## V2500-A5 SERIES PROPULSION SYSTEMS SERVICE BULLETIN

This document transmits the Revision 4 to Service Bulletin V2500-ENG-73-0197.

# V2500-ENG-73-0197

ENGINE – FUEL AND CONTROL – TO PROVIDE A NEW ELECTRONIC ENGINE CONTROL (EEC) WITH A5  
SCN19/X SOFTWARE

LOCATION OF THE ELECTRONIC ENGINE CONTROL  
73-22-34  
FIGURE 1

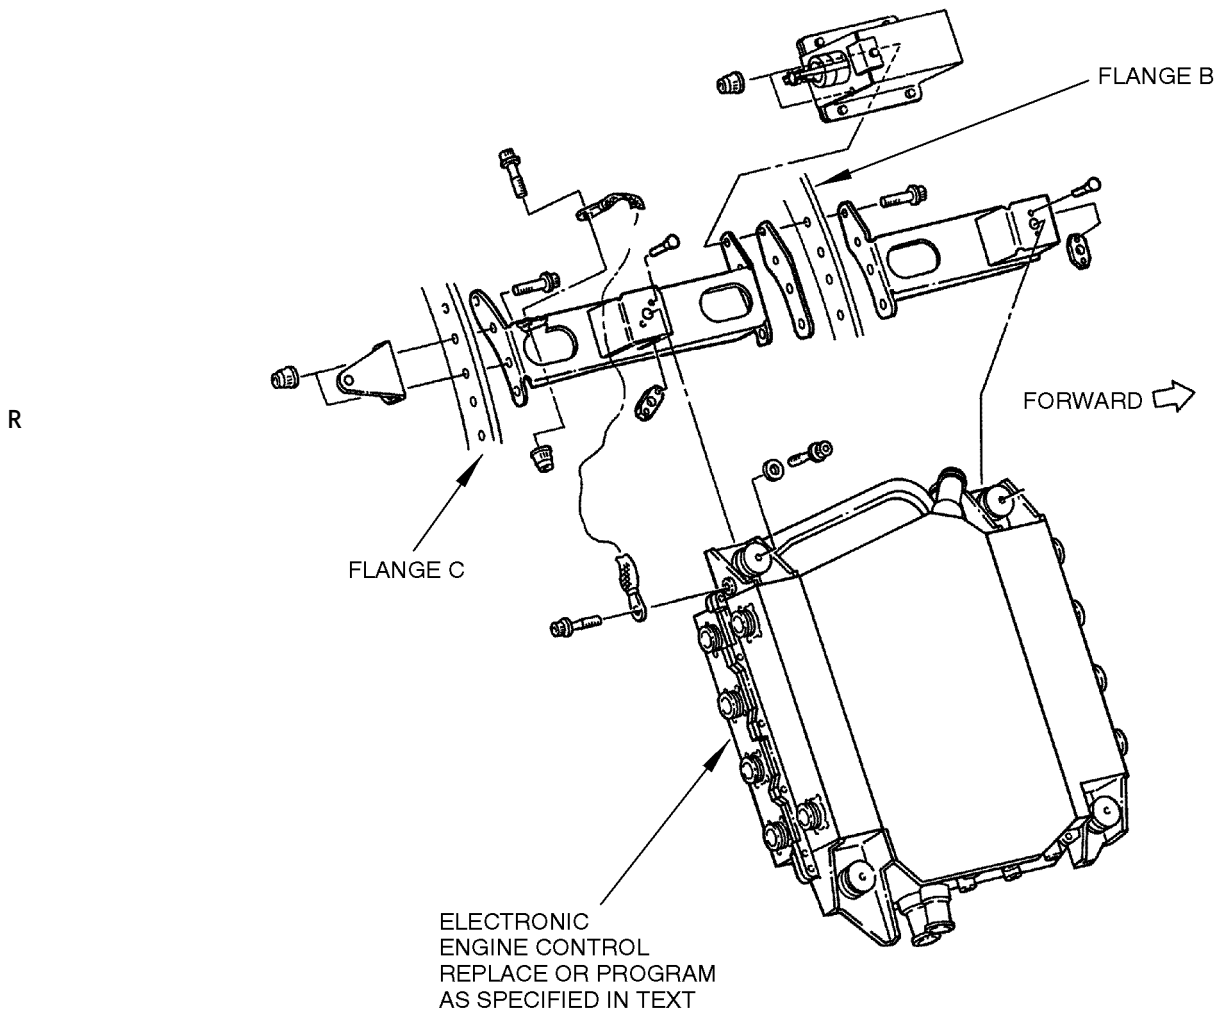
R (1) Remove the EEC as specified in Reference 14, Aircraft Maintenance Manual,  
R Chapter/Section 73-22-34, Task 73-22-34-000-010. See Figure 1 for the  
R location of the part.

Family Tree - Electronic Engine Controller (EEC 150-20) Ref. Catalog Sequence No.  
73-22-34. Fig 01 Item 280  
Chart A (Sheet 1 of 2)

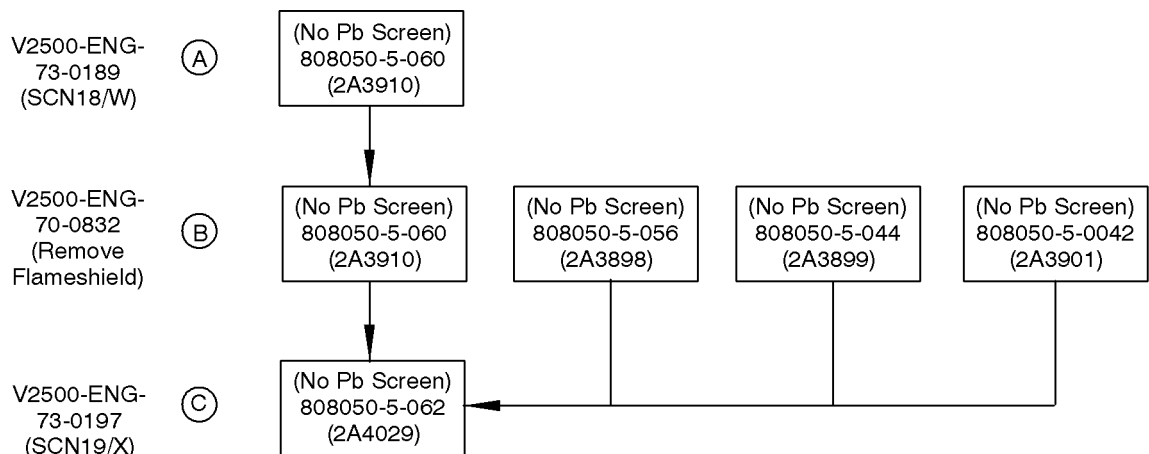
APPENDIX 1Parts Progression To Show the Changed Part in Relation to Other Parts

**Family Tree - Electronic Engine Controller (EEC 150-20) Ref. Catalog Sequence No. 73-22-34. Fig 01 Item 280**  
**Chart A (Sheet 2 of 2)**

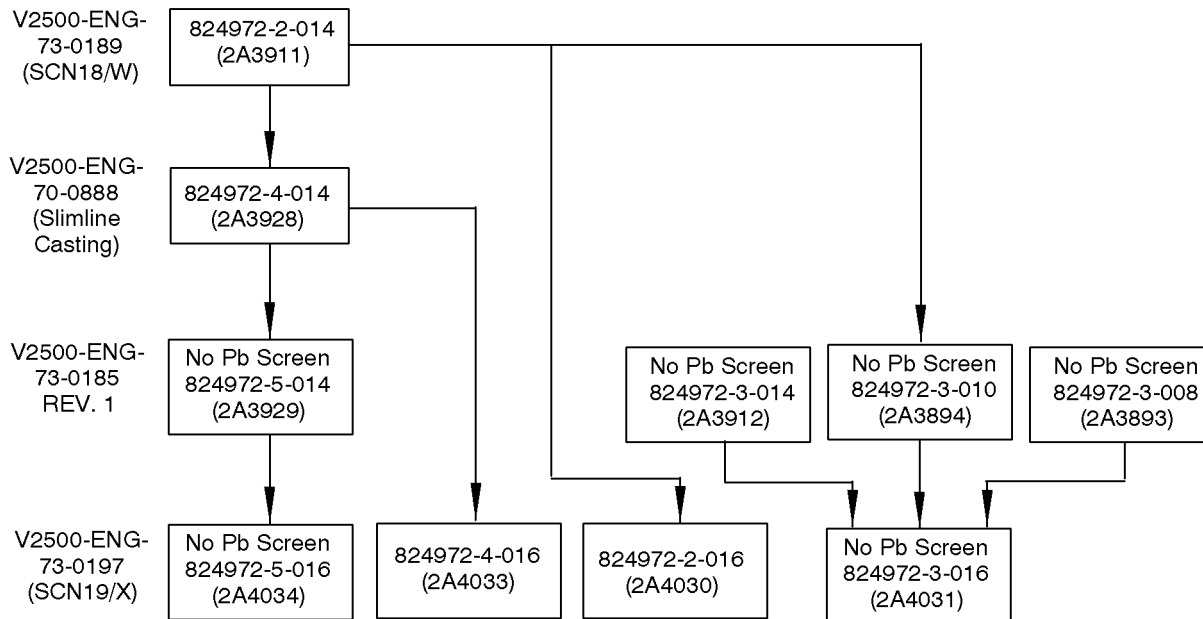
**MODIFICATIONS**
**PART NUMBER CHANGE  
EEC 150-20**
